AGENDA

Architectural Review Board

February 27, 2018

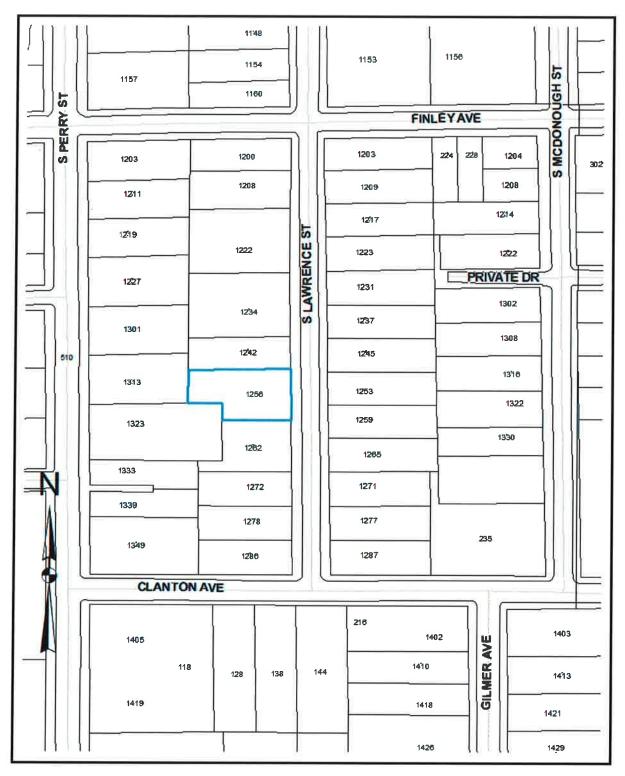
• Proposed replacement should meet city landscape standards (2.5" caliper replacement, no invasive species). No objection to the removal subject to replacement.

reduced-original on file SCALE: 1=10 HOUSE 1227 WOODWARD AVE CONCRETE RIBBON DRIVEWAY EXISTING PECAN TREE 20 REMOVE EXISTING PECAN TREE TUSCARORA CRAPE MYRTLE (2) SIDEWALK EXISTING CONCRETE PAD CONCRETE PAD <u></u>6° GRASS

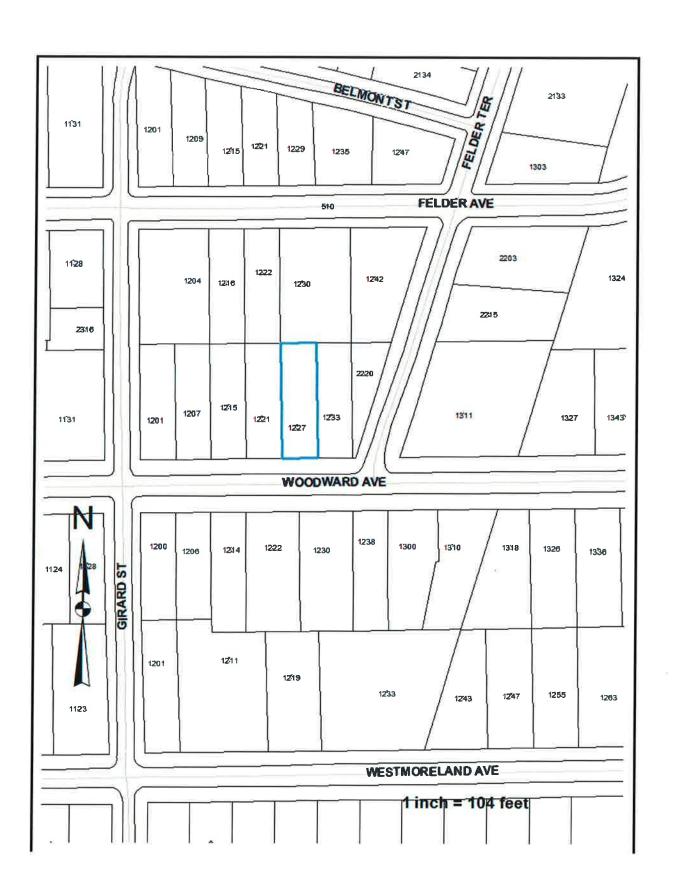
- No objection to the replacement plan locations, 2.5" caliper is the city landscape standard.
- No objection to a single car width driveway

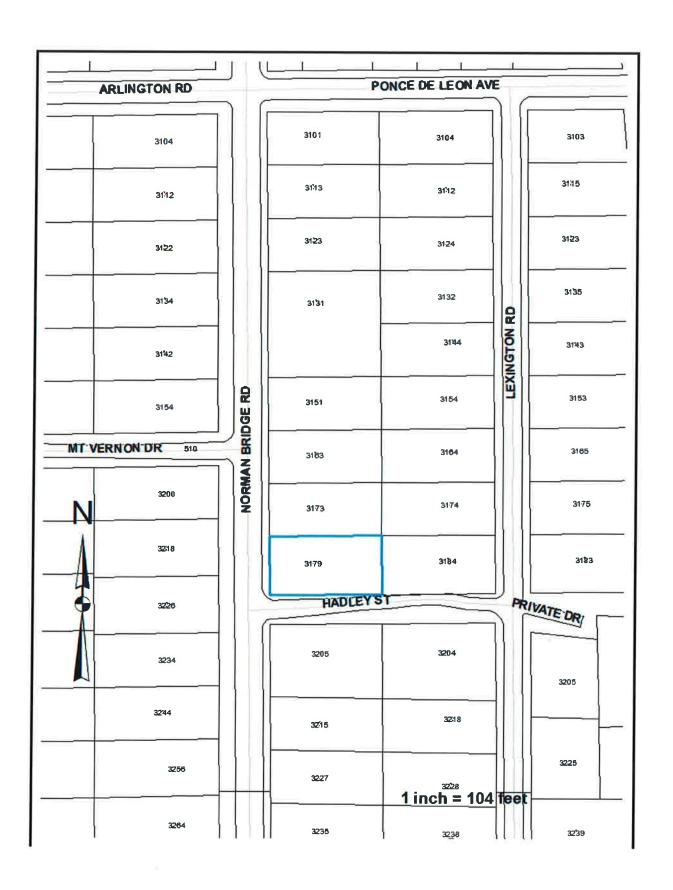
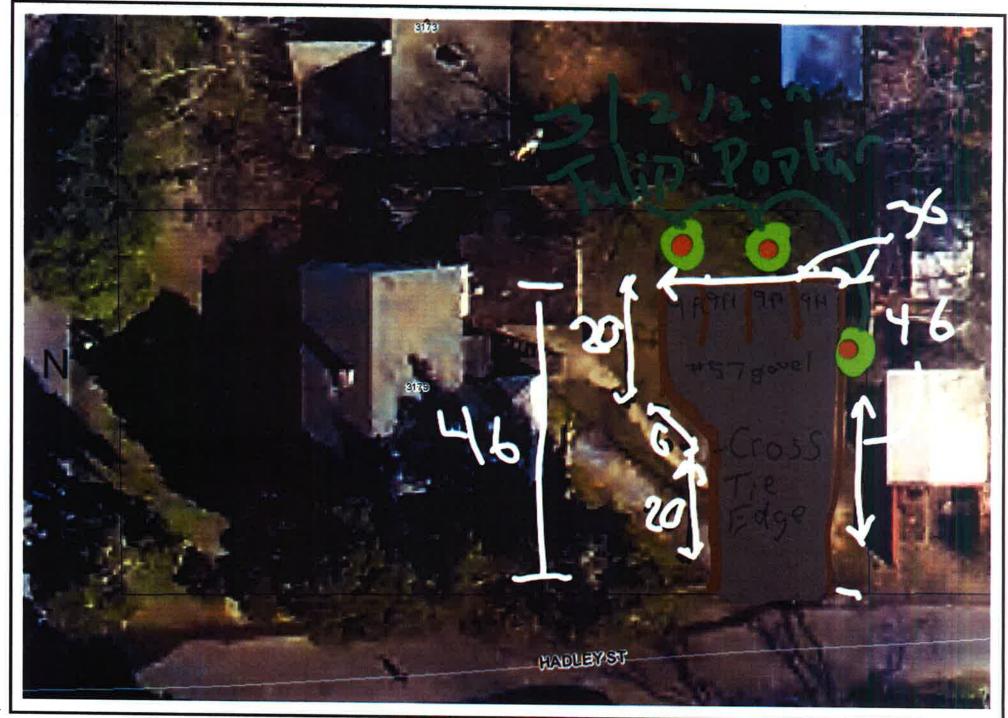
- The large cedar tree was the most significant tree and contributed to the character of the property—this property is part of a plat known as The Cedars. No objection to the replacement plan.
- Rear yard parking is always preferable to paving over a front yard.

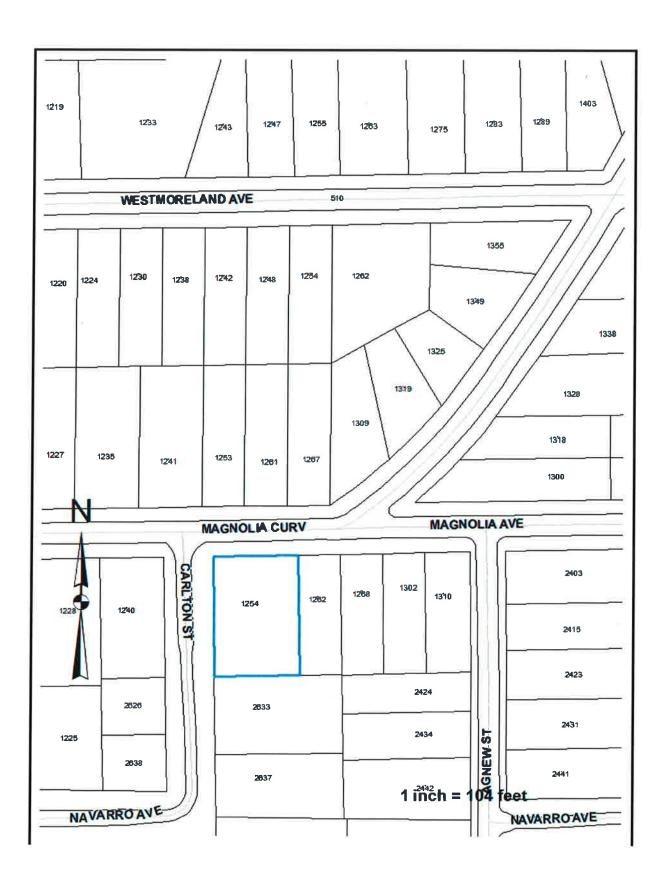
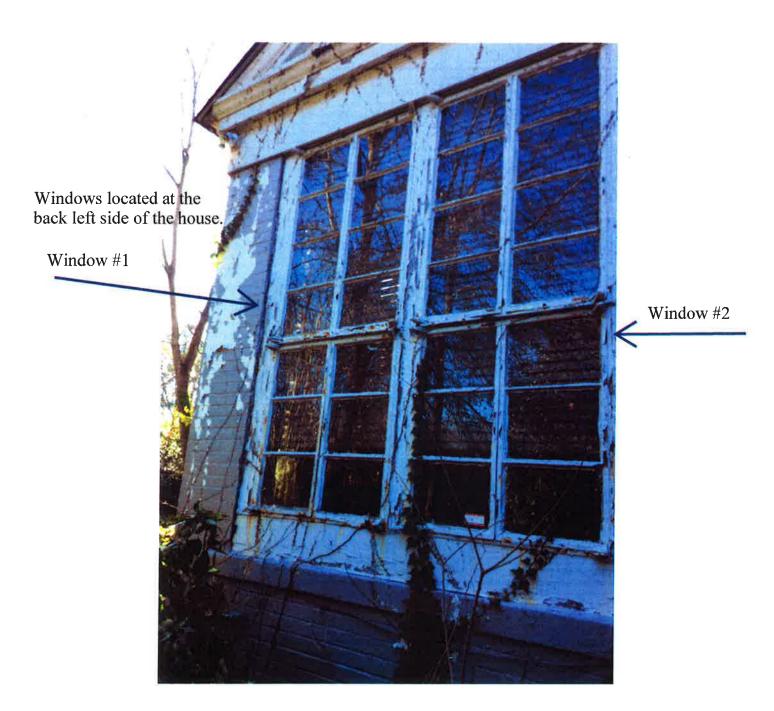
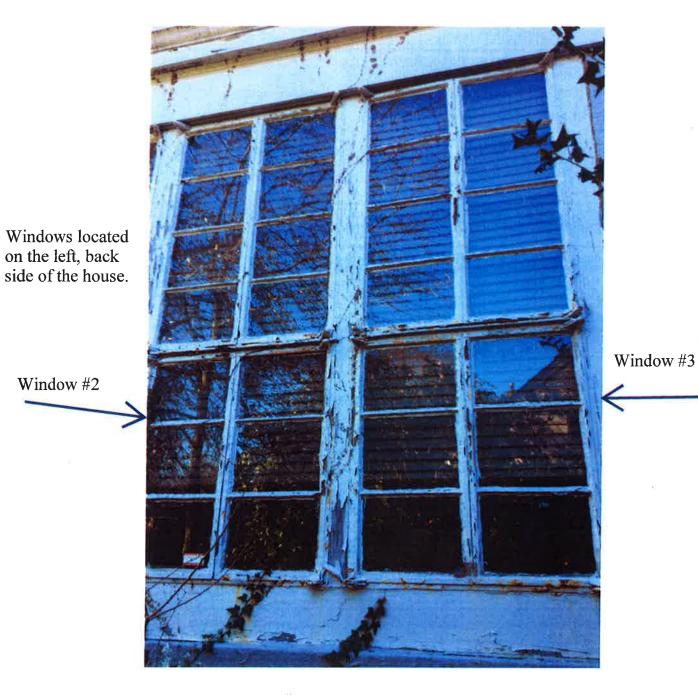
• To date, the Board has NOT approved an extruded vinyl window, and has not approved any window that does not have a grid affixed to the glass. The grid between the glass does not sufficiently simulate the appearance of a true divided lite window. While the SDLs are not perfect, the exterior grid breaks up the plane of the glass to make it appear more like true divided lites with muntins.

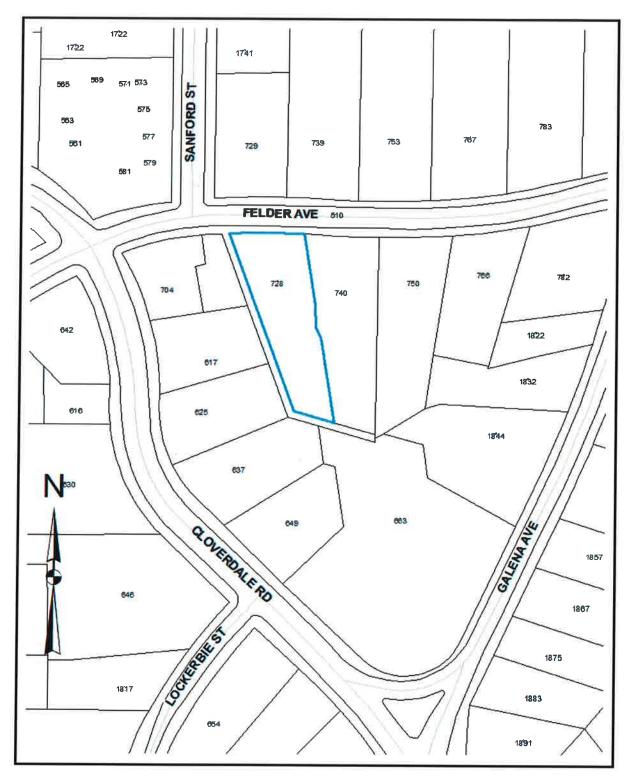
• A variance is required to build that close to a property line, and is on the February 15, 2018 Board of Adjustment agenda.

SITE PLAN					
Project number	er 1710	7.			
Date	12 DEC 2017		A 1		
Drawn by	Author				
Checked by	Checker	Scale	1" = 20'-0"

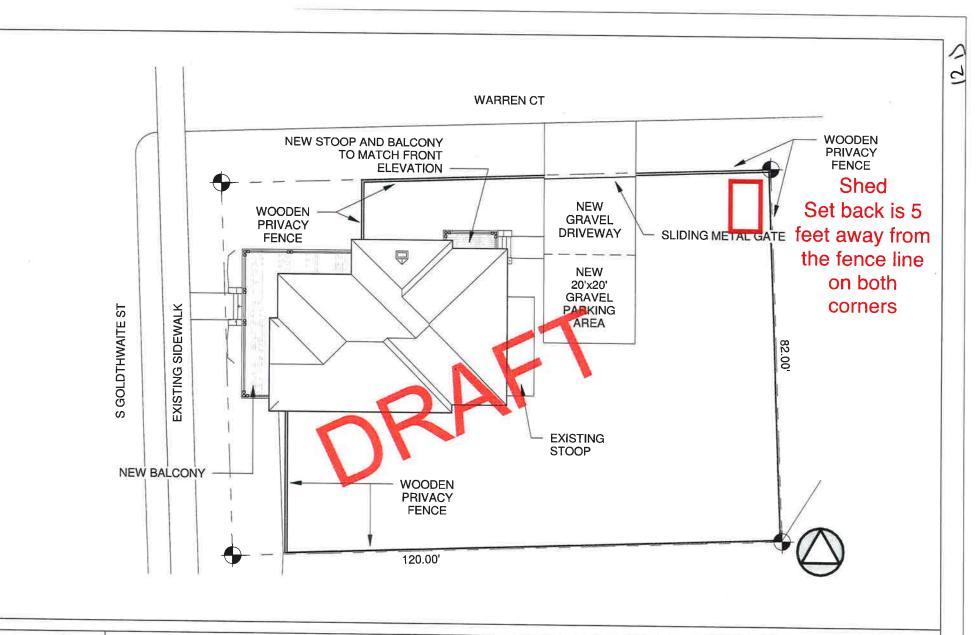
- The arborvitae contributed to the character of the property. Arborvitae were typically planted at the corners of houses.
- Proposed shed placement is compliant with Smart Code requirements.
